**Consumers  
Power  
Company**

DOCKET 50-255, LICENSE DPR-20 -  
PALISADES PLANT - ADDITIONAL INFORMATION  
RELATING TO POWER INCREASE REQUEST

As requested by your staff in the review of our power increase request, the following is forwarded for review.

**Figure  
2-1**

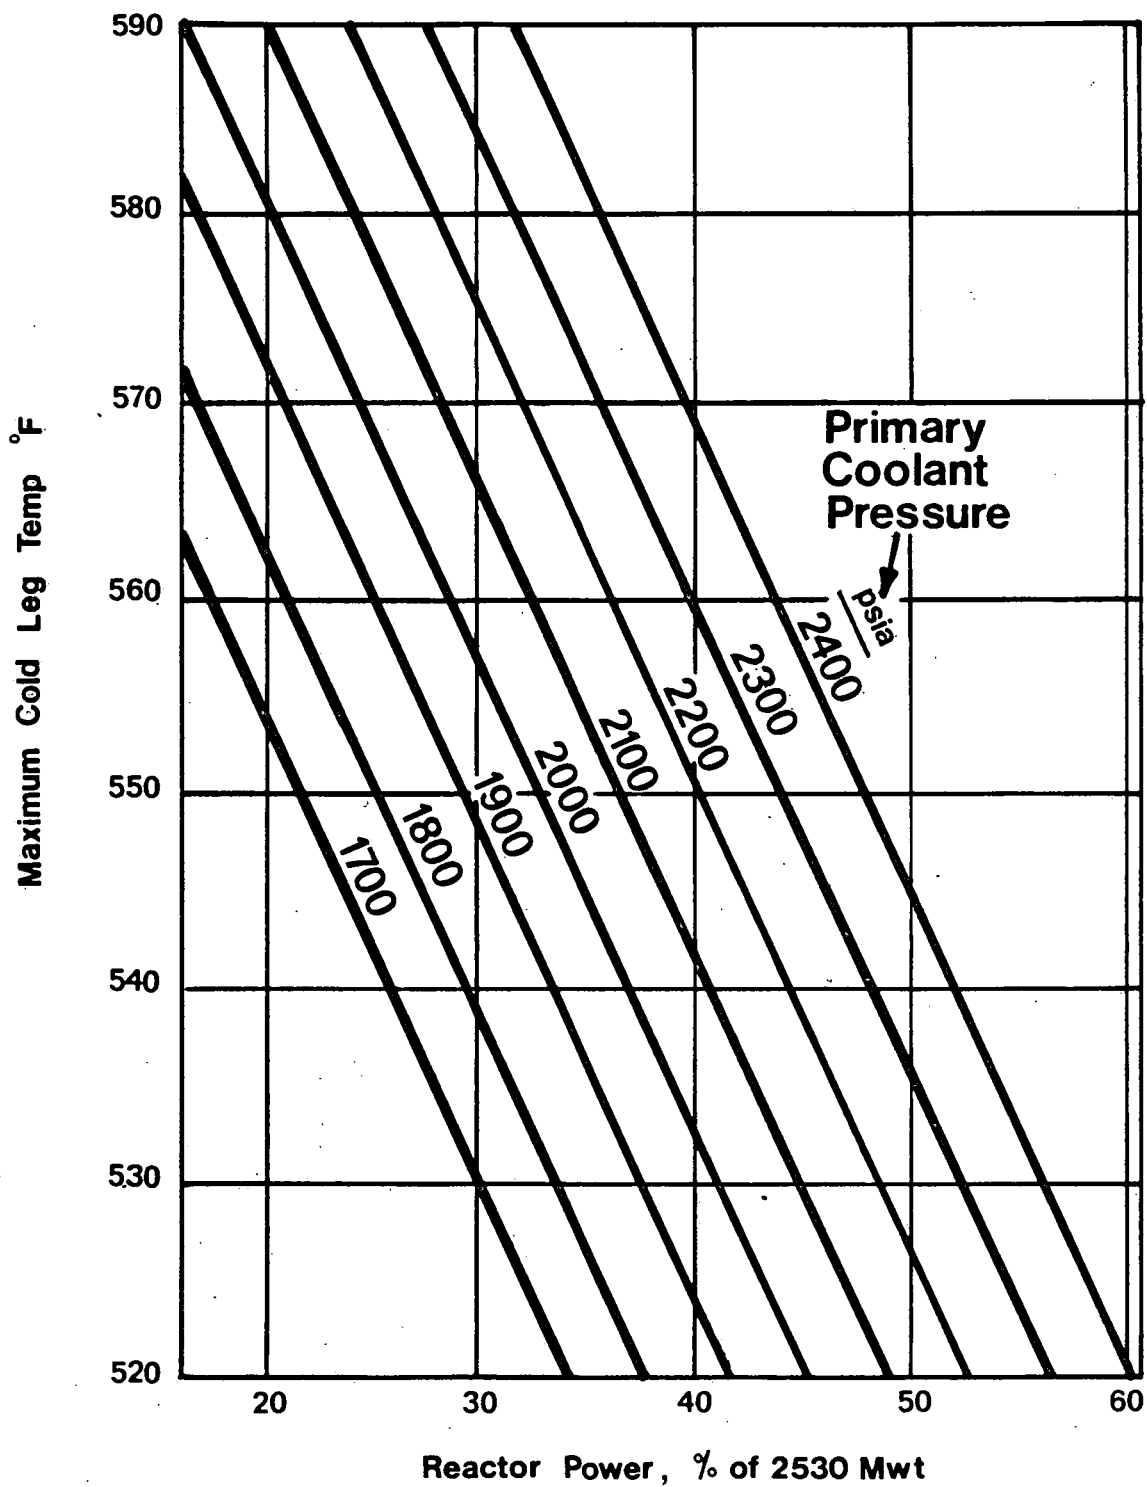
The curves of Figures 2-1, 2-2, and 2-3 represent the loci of points of thermal power, primary coolant system pressure and average temperature of various pump combinations for which the DNBR is 1.3. The area of safe operation is below these lines. For 3- and 2-pump operation, the limiting condition is void fraction rather than DNBR. The void fraction limits assure stable flow and maintenance of DNBR greater than 1.3.

The curves are based on the following nuclear hot channel factors:

3- and 2-Pump Operation:  $F_q^N = 3.62$  and  $F_{\Delta H}^N = 1.94$

4-Pump Operation:  $F_q^N = 2.48$  and  $F_{ROD}^N = 1.77^*$

FIGURE  
3-6

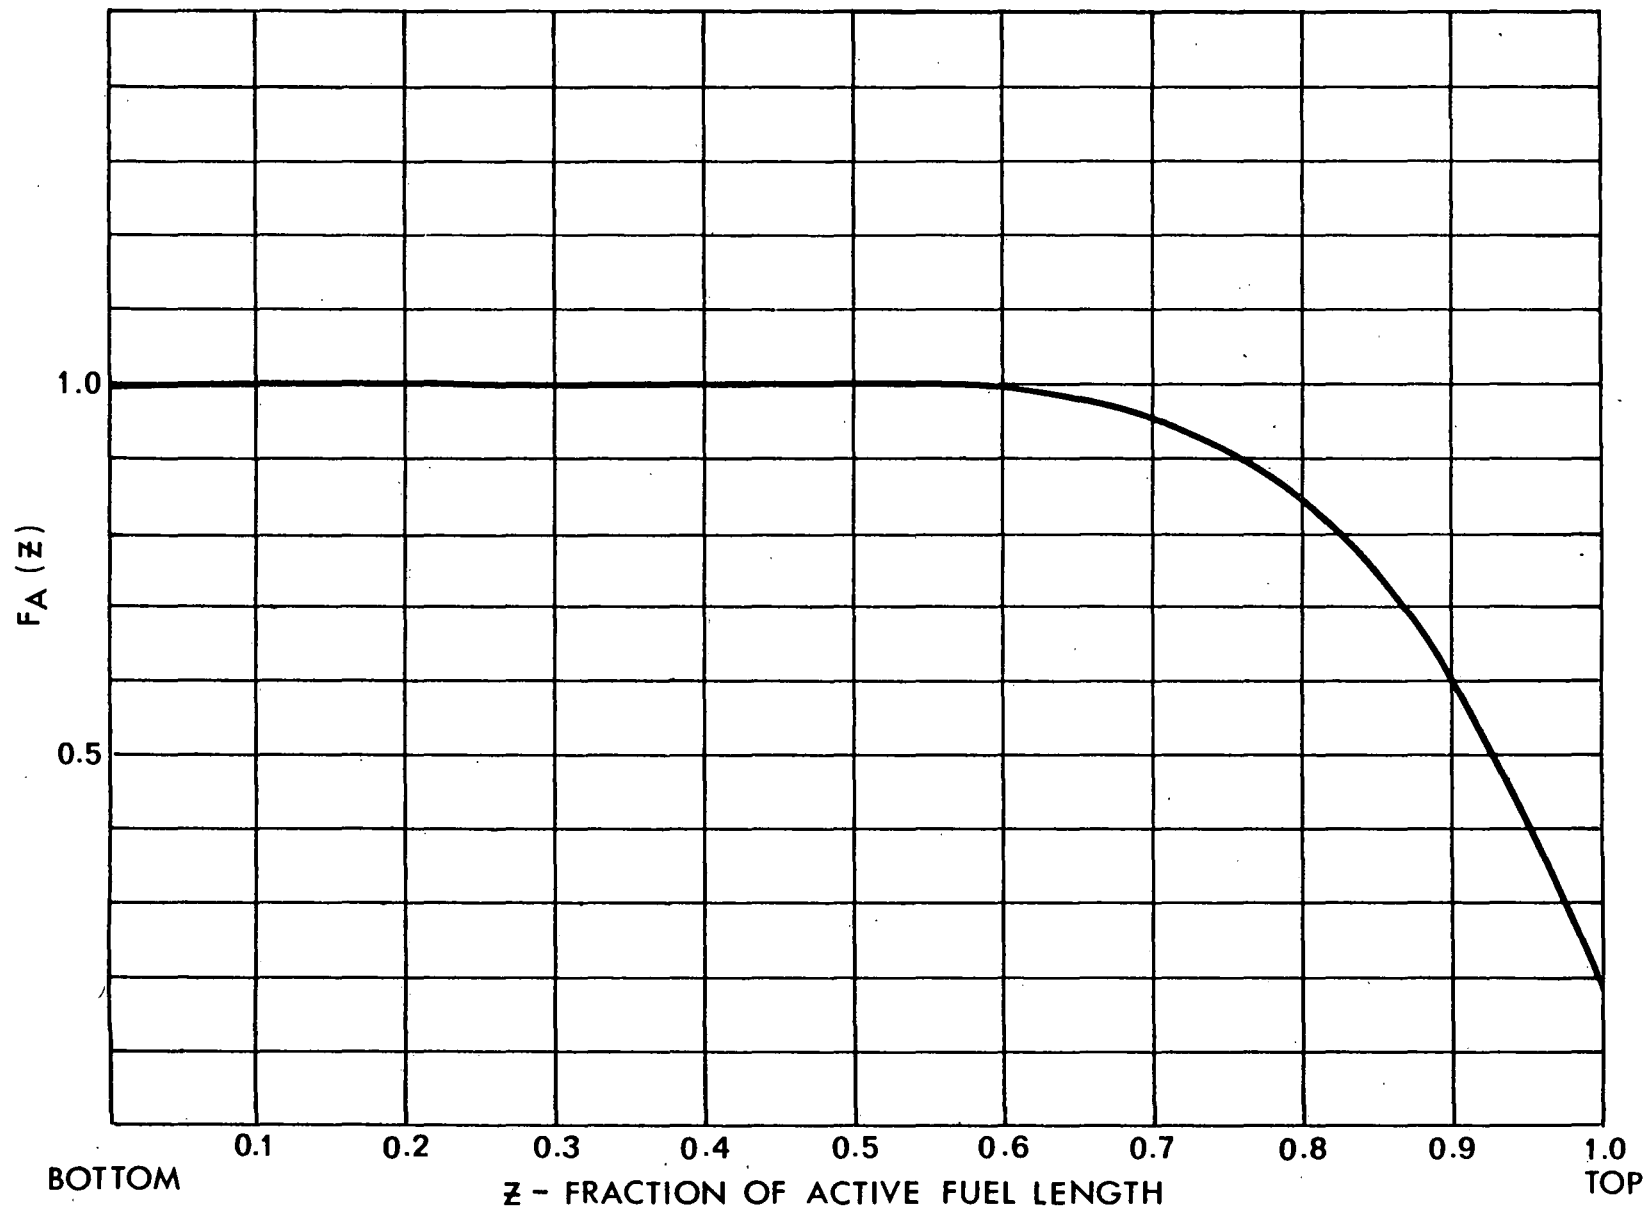
- a. To implement the limits on shutdown margin, individual rod worth and hot channel factors, the limits on control rod regulating group insertion shall be established as shown on Figure 3-6. The 4-pump operation limits of Figure 3-6 do not apply for decreasing power level rapidly when such a decrease is needed to avoid or minimize a situation harmful to the plant personnel or equipment. Once such a power decrease is achieved, the limits of Figure 3-6 will be returned to by borating the control rods above the insertion limit within two hours. Limits more restrictive than Figure 3-6 may be implemented during fuel cycle life based on physics calculations and physics data obtained during plant start-up and subsequent operation. New limits shall be submitted to the NRC within 45 days.

Figure  
3-9

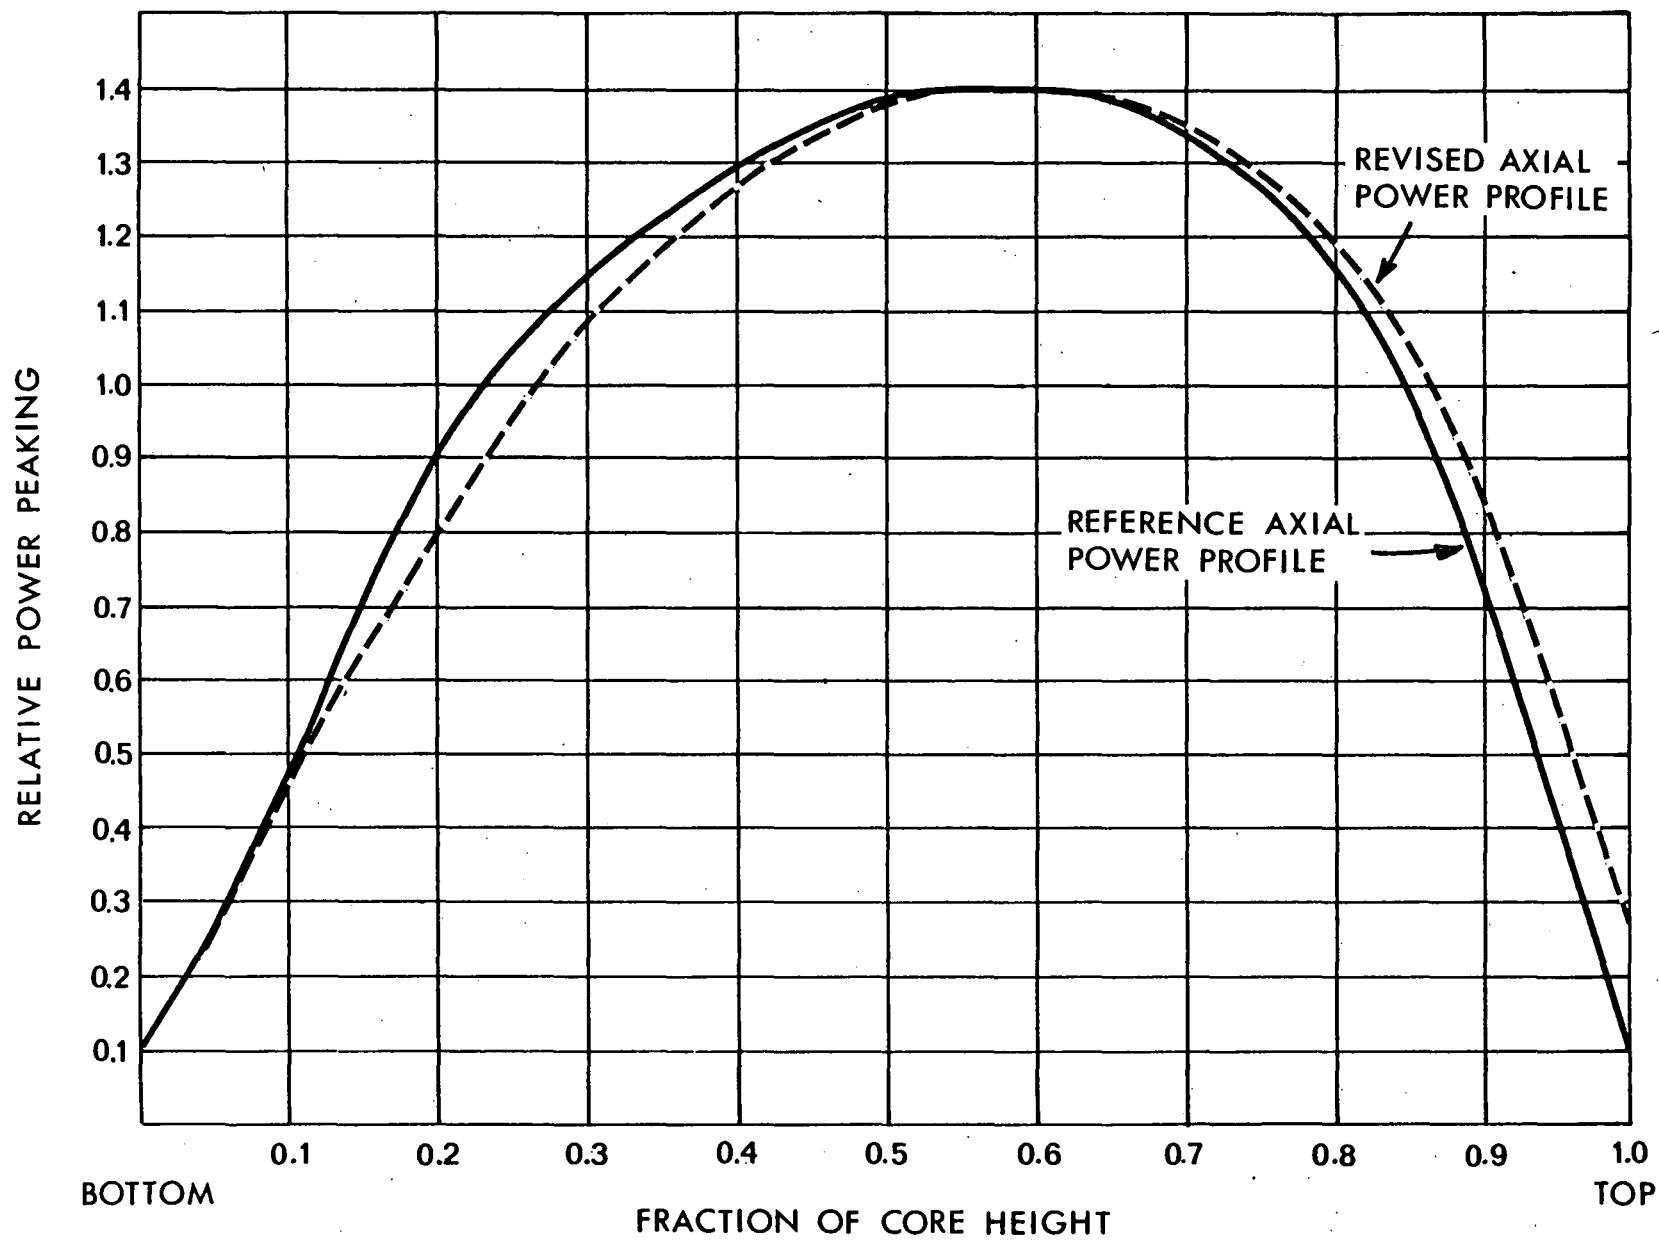
A review of Figure 3-9 has indicated that the axial correction factor proposed may be overly conservative and hence limit plant operations unnecessarily. This may be particularly true at end-of-cycle when neutron flux levels in the top 20% of the core are highest due to the "double-humped" power profile which is characteristic of EOC. Therefore, Figure 3-9 has been revised. The revised axial correction factor allows for slightly more flexibility in operating the reactor with top-peaked axial power profiles. The axial correction factor shown on Figure 3-9 was derived based on a revised axial power profile. For this revised power profile, power production in the top of the core was somewhat greater than that for the reference power profile that was used in evaluating the plant transients and LOCA for 2530 Mwt operation.<sup>(1,2)</sup> Refer to Figure 1 for a graphical comparison of the two power profiles. An evaluation of the limiting LOCA (i.e. the 0.6 DEG for D-fuel) and of DNB thermal margins using the revised axial power profile has shown that the revised profile results is a slight improvement in LOCA and DNB margins.<sup>(3,4)</sup> Therefore, the revised axial correction factor is conservative with respect to that previously proposed.
